KU-RING-GAI LOCAL PLANNING PANEL MEETING TO BE HELD ON MONDAY, 1 JUNE 2026 AT 10:00 AM BY ZOOM CONFERENCING

- GB.1 **4-10 Bridge Street, Pymble - Demolition of the existing structures and construction of a mixed-use commercial (specialised retail and office) building, basement parking and associated works**

REPORT TITLE:	4-10 BRIDGE STREET, PYMBLE - DEMOLITION OF THE EXISTING STRUCTURES AND CONSTRUCTION OF A MIXED-USE COMMERCIAL (SPECIALISED RETAIL AND OFFICE) BUILDING, BASEMENT PARKING AND ASSOCIATED WORKS
ITEM/AGENDA NO:	GB.1

APPLICATION NO:	eDA0462/25
ADDRESS:	4-10 Bridge Street, Pymble
WARD:	Gordon
DESCRIPTION OF PROPOSAL:	Demolition of the existing structures and construction of a mixed-use commercial (specialised retail and office) building, basement parking and associated works
APPLICANT:	Fife Capital Pty Limited
OWNER:	Perpetual Corporate Trust Limited
DATE LODGED:	4 September 2025
SUBMISSIONS:	Nil
ASSESSMENT OFFICER:	Luke Donovan
RECOMMENDATION:	Refusal

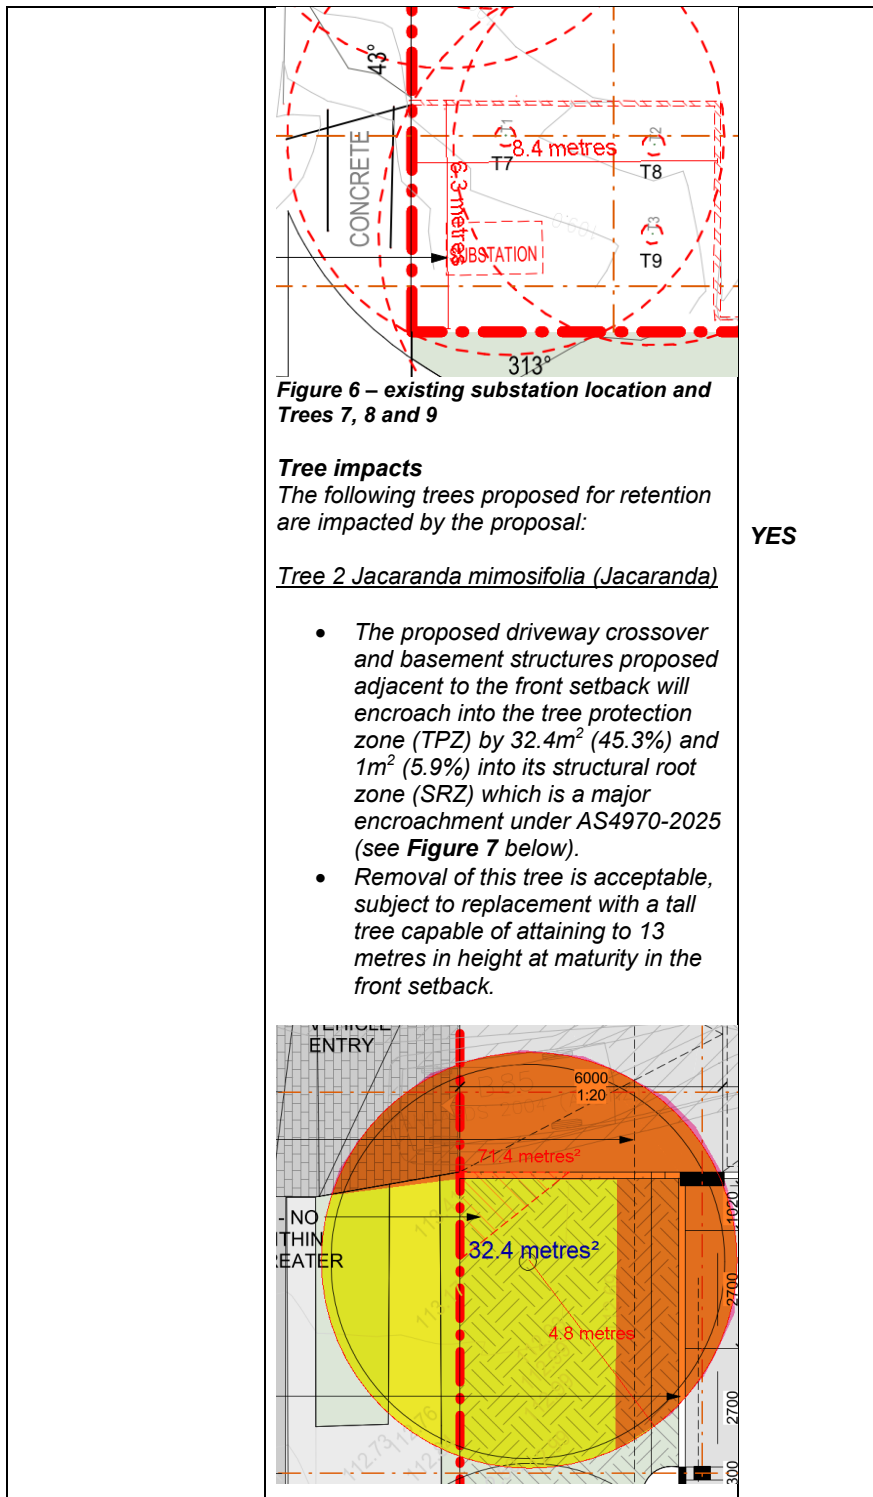
<p><i>The front setback should include a minimum 2.5 metres wide deep soil zone. The proposal currently provides deep soil only over an area measuring approximately 12.4 metres in length and 3.6 metres in width.</i></p>	<p>NO</p>
	<p><i>To achieve a softer interface with the public domain, it is recommended that the existing substation be retained in its current location (within the area of approximately 6.3 metres by 8.4 metres) and that existing Trees 7, 8 and 9 be retained (see Figure 6 below). The existing substation may be upgraded, maintaining its location, if required.</i></p>

Figure 11 – Looking south-east from Bridge Street towards the site and the adjoining driveway to the Bunnings site. The stand of trees in the centre of the figures are Trees 7, 8 and 9 alongside the existing substation.

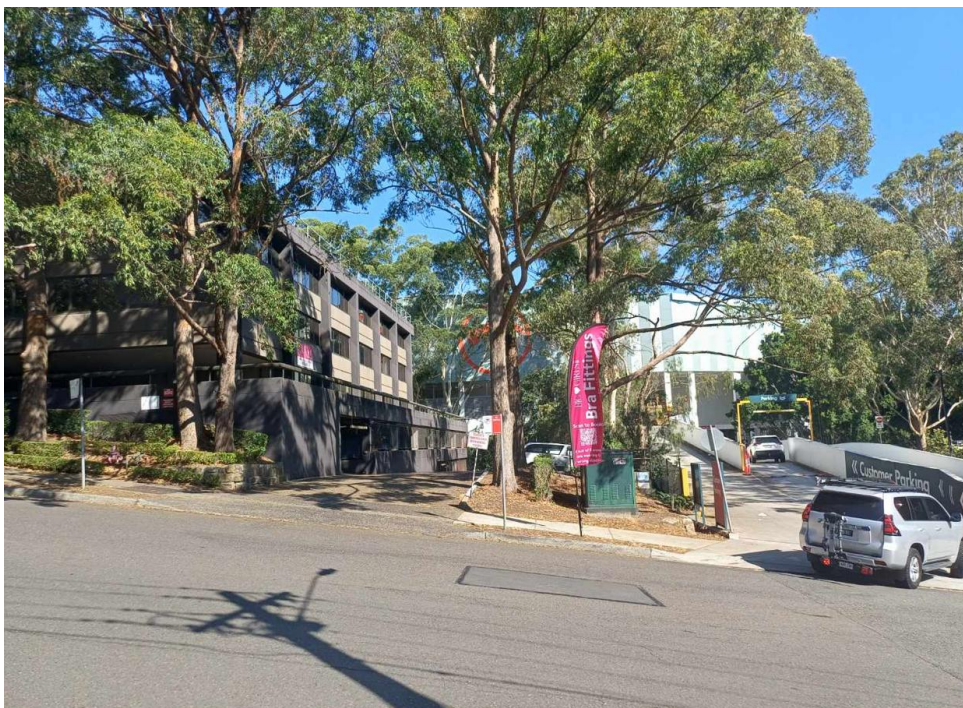
It is agreed that Trees 7, 8 and 9, located adjacent to the existing substation in the western corner of the site (refer to **Figure 11** below) contribute greatly to the landscape character along Bridge Street and assist in providing a visual landscape buffer with the driveway to the adjoining site (See **Reason 3**). Whilst it is accepted that this would necessitate a re-design of the basement egress driveway, this is reasonable in the site circumstances. The existing driveway could be utilised to facilitate basement egress and a loading dock area.

Figure 14 – Mark-up of Lower Ground Floor indicating potential location for visitor bicycle spaces

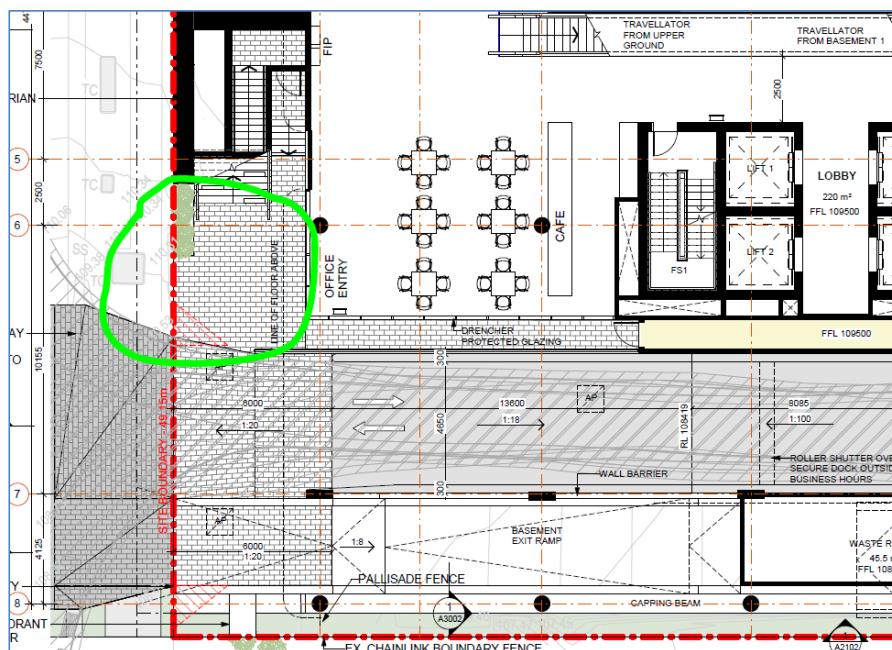
Visitor bicycle parking is also located on the Basement 1 level, and similar ramp grade accessibility issues as employees arise. Additionally, there is concern regarding the practicality and convenience of visitors entering the basement parking area to access the bicycle parking from the main car park entry ramp. Therefore, it could be conditioned, if approval was recommended, that the application provide a minimum of 4 racks for visitor bicycles located somewhere near the accessible entrance on the Lower Ground Floor level (circled in green, in extract from the Architectural Plans – Lower Ground Floor) below in **Figure 14**:

Figure 15 - Visibility splay for service vehicles

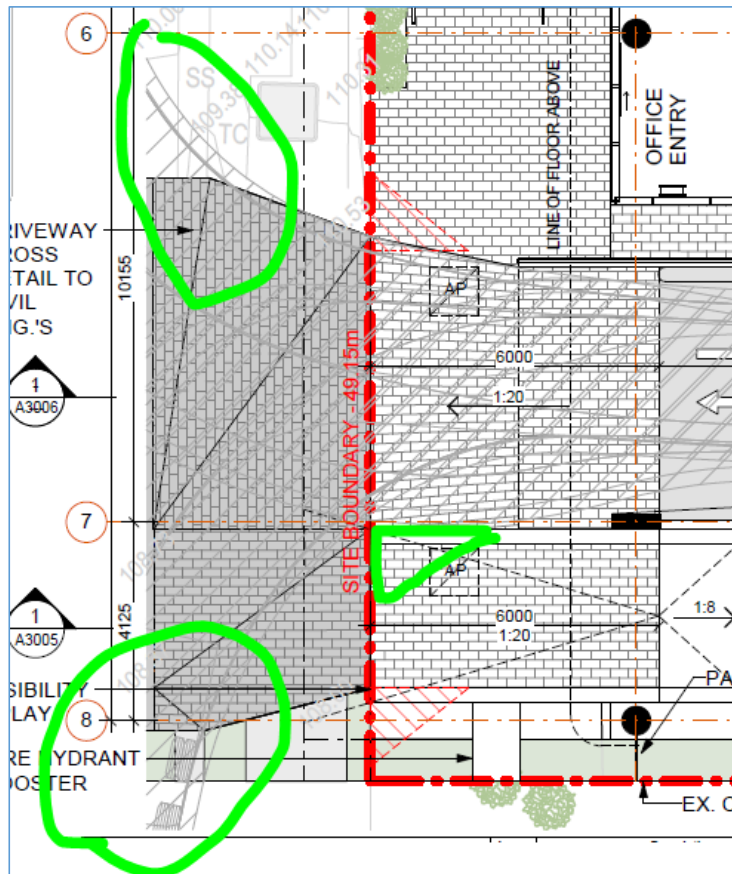
Clarification is required that the visibility splay for service vehicles in the area (indicatively marked up with a green triangle below) has been provided in **Figure 15** below:

Figure 1: Visibility splays and manoeuvrability for service vehicles

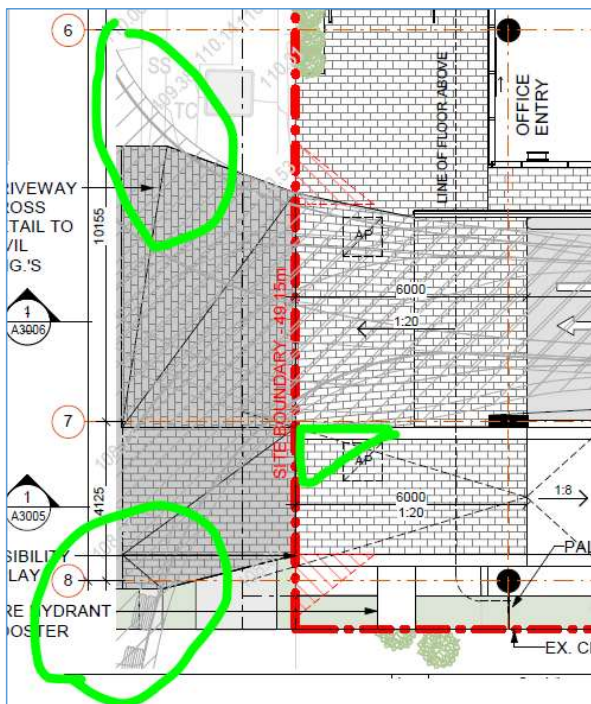
Clarification is required that the visibility splay for service vehicles in the area (indicatively marked up with a green triangle in Figure 1 below) has been provided:

Also, clarification is required on the heavy vehicle swept paths, which are currently shown on the architectural plans as straying outside the proposed driveway crossing (circled in green in Figure 1 above). Clarification is required that heavy vehicles can access the service area while staying wholly within the driveway crossing

Drawing Title
**UPPER GROUND FLOOR PLAN
 PROPOSED PODIUM ACTIVATION**
 SHEET NUMBER
1200065_ ASK- 011
 ISSUE
B

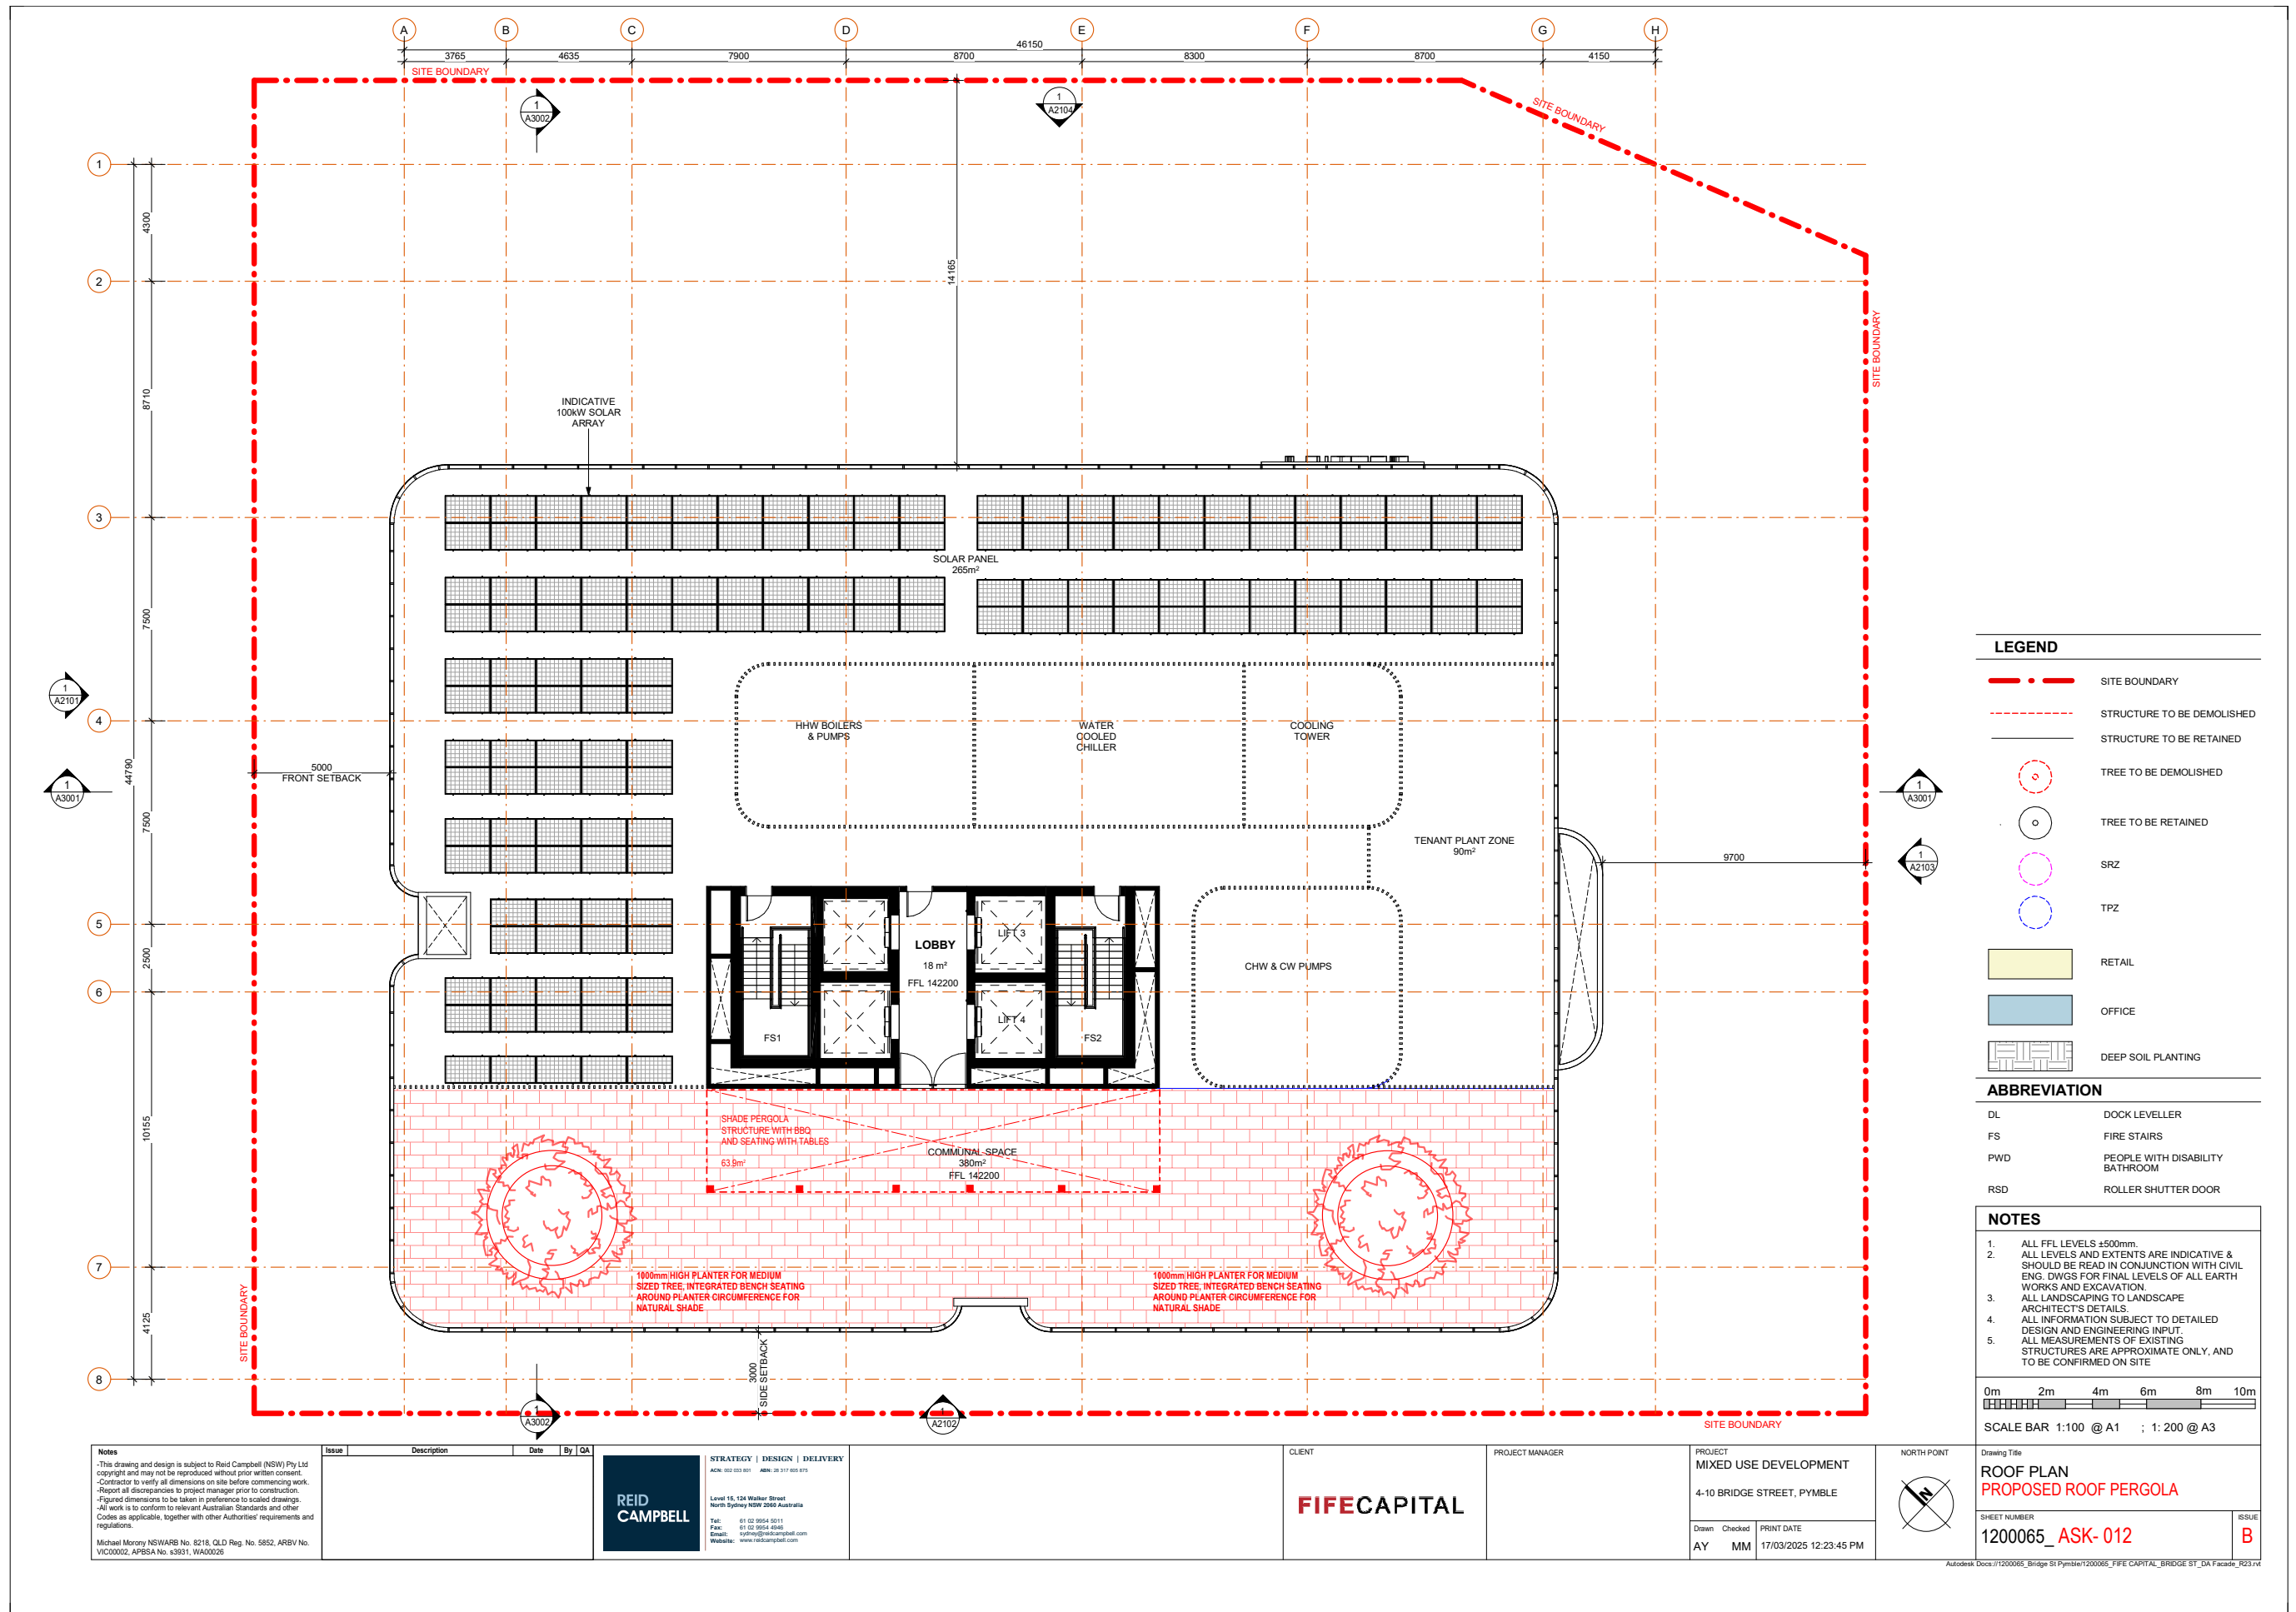
On 2 April 2026, Council provided a response to the various options presented by the applicant at the meeting on 31 March 2026 (**Attachment A21**). In summary, it was Council's view that the following design changes could be made at both the lower ground floor and upper ground floor to assist in addressing issues relating to street activation and pedestrian entry –

Figure 1 Proposed Section / Northern Side Setback

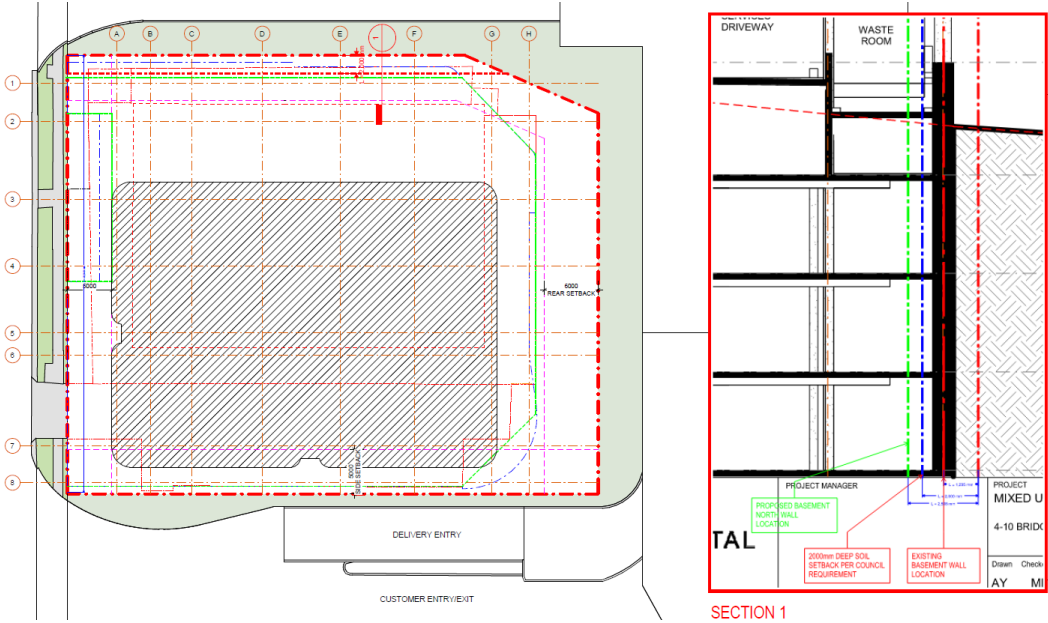
The design changes, which are illustrated in the revised plans, have adjusted the siting of the building in accordance with the site-specific side setback controls, which allows for a zero setback along the southern boundary of the site (refer Figure 14G.4-1 KDCP). This move, of around 800mm, has resulted in the following outcomes:

Figure 1 below provides a section through the northern side boundary, demonstrating the location of the existing basement, the minimum 2m setback, and the proposed setback. As confirmed in the advice prepared by Birds Tree Consultancy (Appendix L) which supports this response, along with the structural advice prepared by TTW (Appendix XM), this approach is considered viable to ensure tree retention described above.

Figure 2 Proposed additional pedestrian entry location

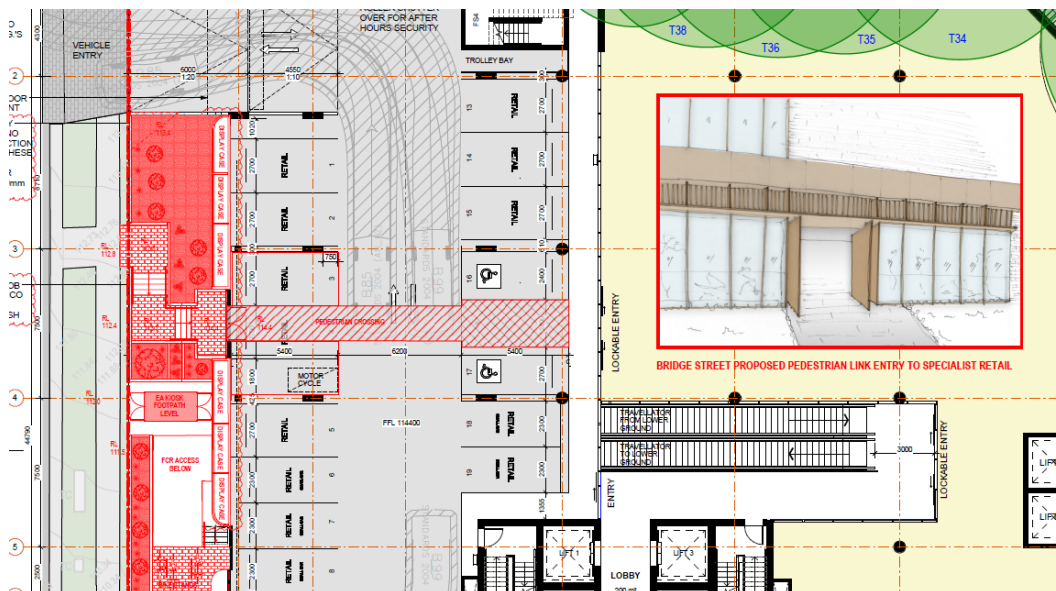
The outcome proposed in the submitted plans addresses these recommendations and seeks to locate an additional pedestrian access location, generally central to the building façade, enabling access from Bridge Street onto the upper ground car park via a set of well-defined/designed stairs. Key to this design, was the splitting of the existing proposed display cases, which and now proposed to sit either side of the stairway (see figure below).

Figure 3 Rooftop Communal Open Space

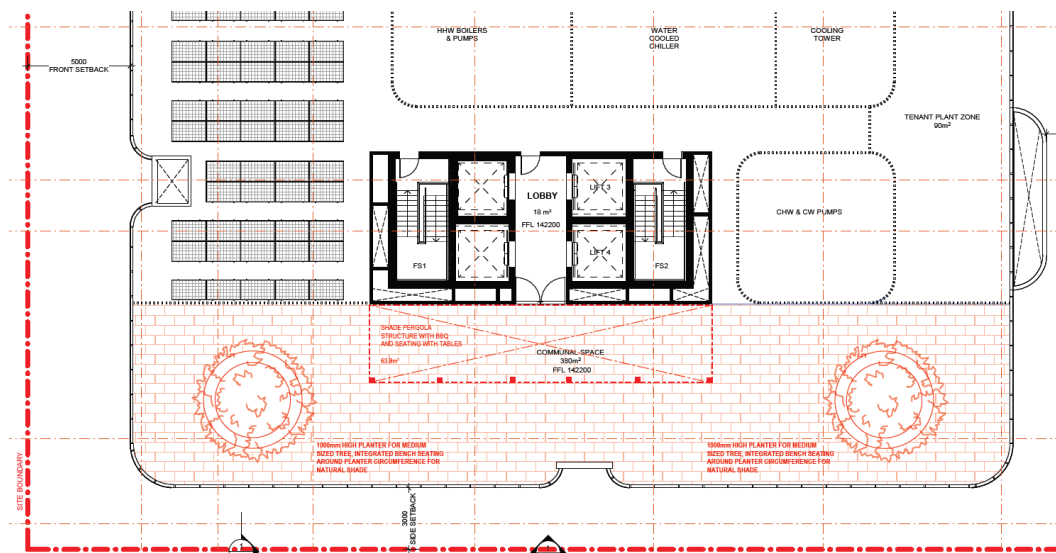
In response to this, and forming part of the plans submitted with this response, a shade pergola structure with BBQ and seating/tables underneath is proposed adjacent the lift core on the rooftop and is shown on the submitted plans. The location is central, and unlikely to be visible from adjacent properties (refer Figure 1 below). Additional landscaping is also proposed on the rooftop to further improve amenity for users.
